PUBLIC INTEREST REVIEW FOR GROUNDWATER APPLICATIONS

TO: Water Rights Section Date 12/17/2015
 FROM: Groundwater Section Phillip I. Marcy / Ivan K. Gall
 SUBJECT: Application G- 18127 Reviewer's Name
 Supersedes review of _____ Date of Review(s) _____

A. GENERAL INFORMATION: Applicant's Name: Randy Rupp County: Baker

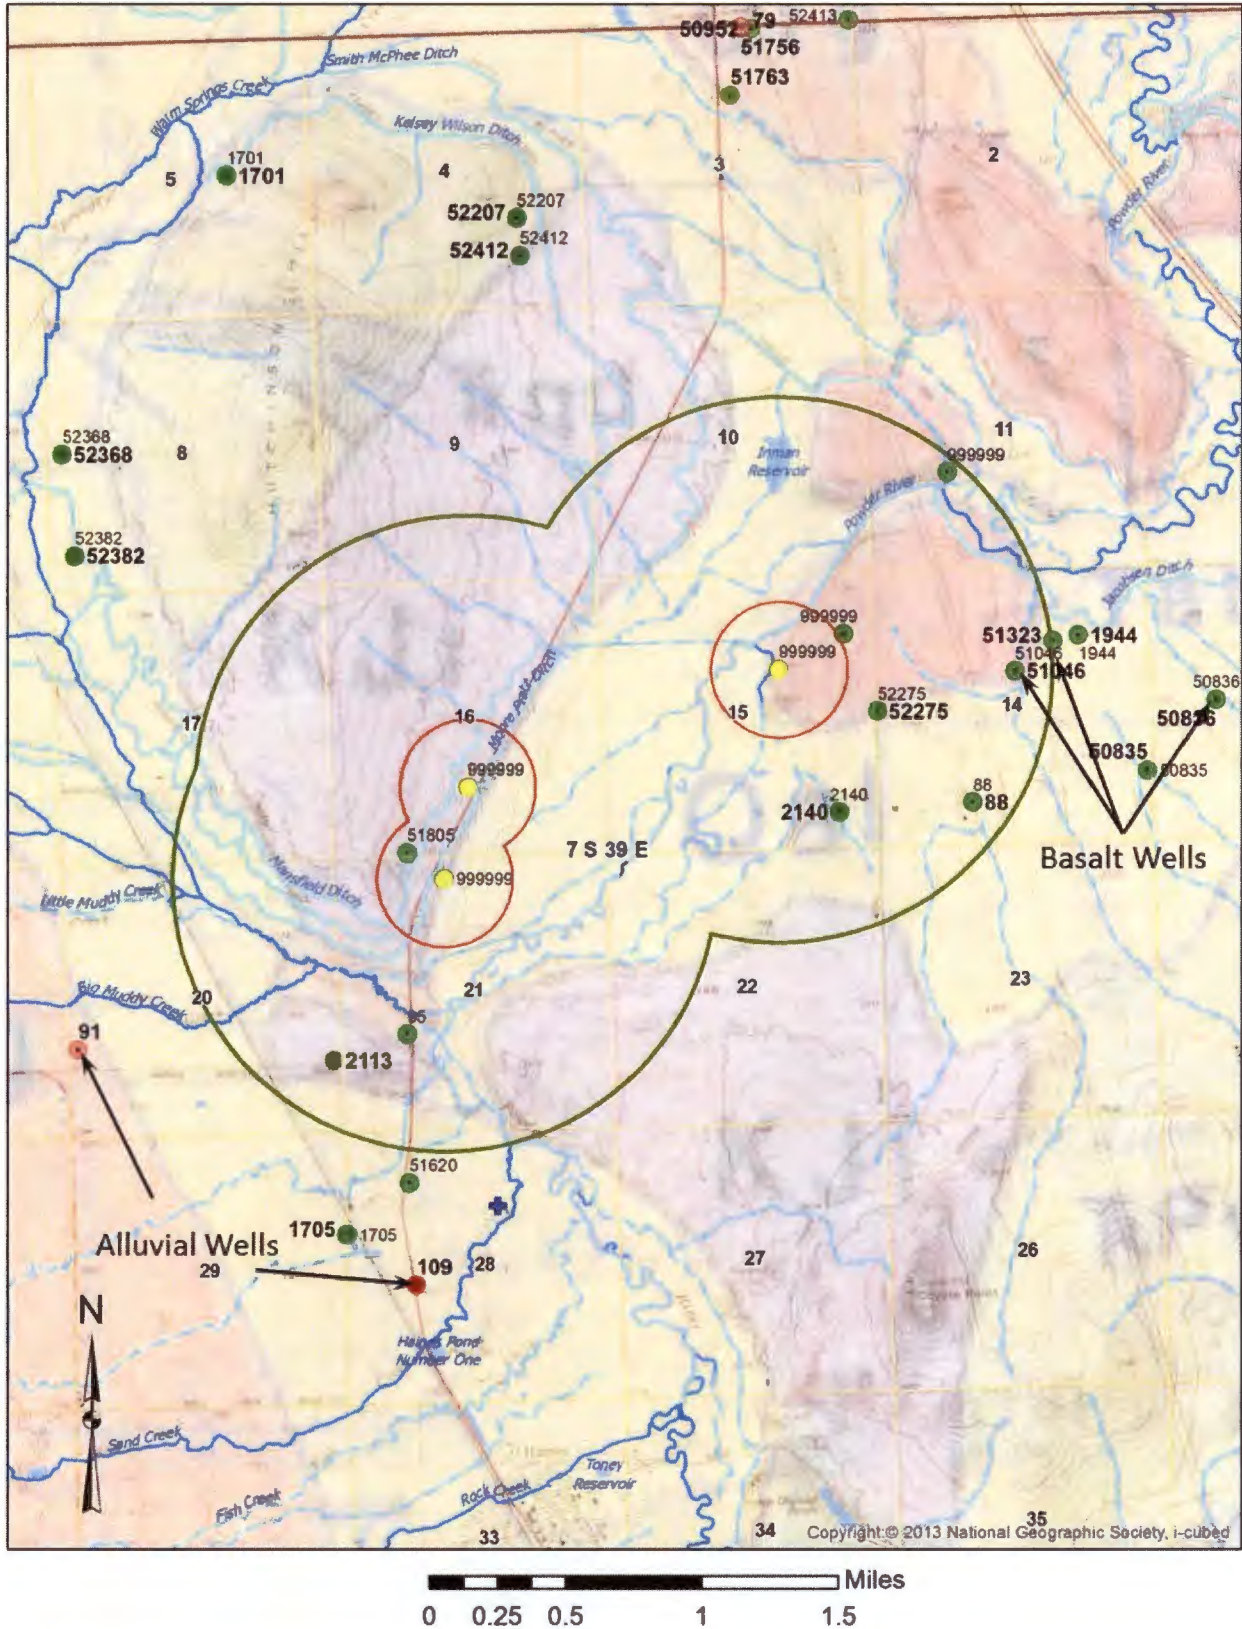
A4. **Comments:** Wells 2 and 3 may not encounter basalt at their proposed locations, as nearby logs encounter only Mesozoic granite at depth (BAKE 51805, 0.25 miles to west; BAKE 95, 0.5 miles to the south). Local wells producing from granite tend to have low yield (10-15 GPM). Well logs within 1 mile, and to the east of the proposed location of Well 1 report the occurrence of basalt at elevations from 3130 to 3247 feet AMSL, but other nearby logs encounter granite without reporting basalt. Static water levels provided are from nearby BAKE 52275, completed into the same proposed basalt aquifer system.

B3. **Groundwater availability remarks:** Wells 2 and 3 are likely to encounter granite at very shallow depths, as shown by nearby well logs (BAKE 51805, BAKE 95), and geologic maps of the area (Brooks and others, 1976). Wells producing from granite aquifers in the area have stated yields of between 12 and 300 GPM, with the most productive wells reporting "decomposed granite sand". Few highly productive local wells to the north of the proposed POA locations report basalt at depth, both above and beneath granite (BAKE 52412, BAKE 52413). This may indicate the presence of a reverse fault to explain the superposition of intrusive Mesozoic granite above basalt, but this relationship would only likely be encountered very near the strike of the possible thrust fault.

1. Best management practices shall be used to maximize the efficiency of water use.
2. If a permit is issued, proposed POA wells shall only produce from the basalt aquifer, and shall be constructed with continuous case and continuous seal at least 10 feet into basalt. Wells shall not be constructed to produce from, or allow hydraulic connection to, the shallow alluvial or granite aquifer systems.

Figure 2: Nearby wells completed into basalt (BAKE 51323, BAKE 51046, BAKE 50836) show similar groundwater elevations, below that of surface streams in the area.

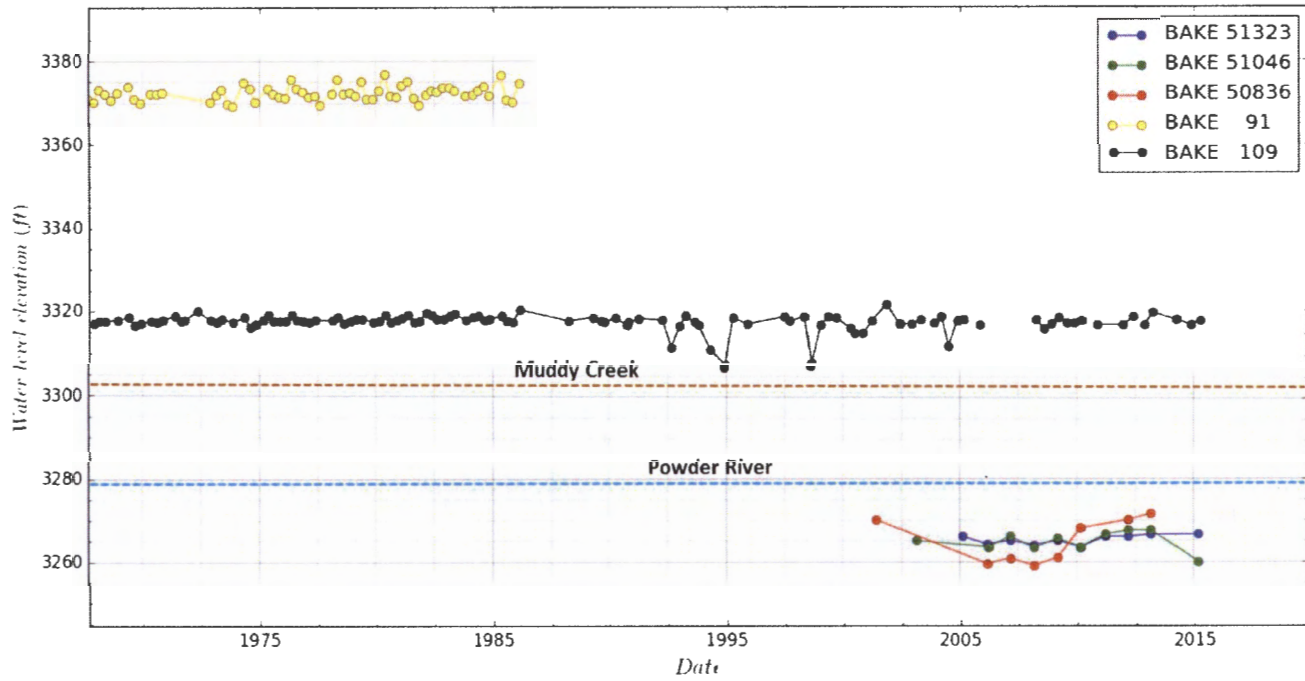
Basis for aquifer hydraulic connection evaluation: Effective hydraulic connection between competent basalt and the shallow alluvial aquifer system (units Qal and Qtg of Brooks and others, 1976), and therefore to surface water is likely quite inefficient. Effects from pumping from within or beneath laterally extensive lava flows are typically limited to wells with similar construction, or locations in which the stratigraphy has been incised to the extent that springs and streams emerge at the land surface. Any effects of pumping from the basalt aquifer system at this location are not likely to be observed on surface water within 1 mile. The lack of an efficient hydraulic connection with nearby streams can also be demonstrated by the lack of correspondence between groundwater elevation in local basalt wells and nearby surface waters (Figure 2).
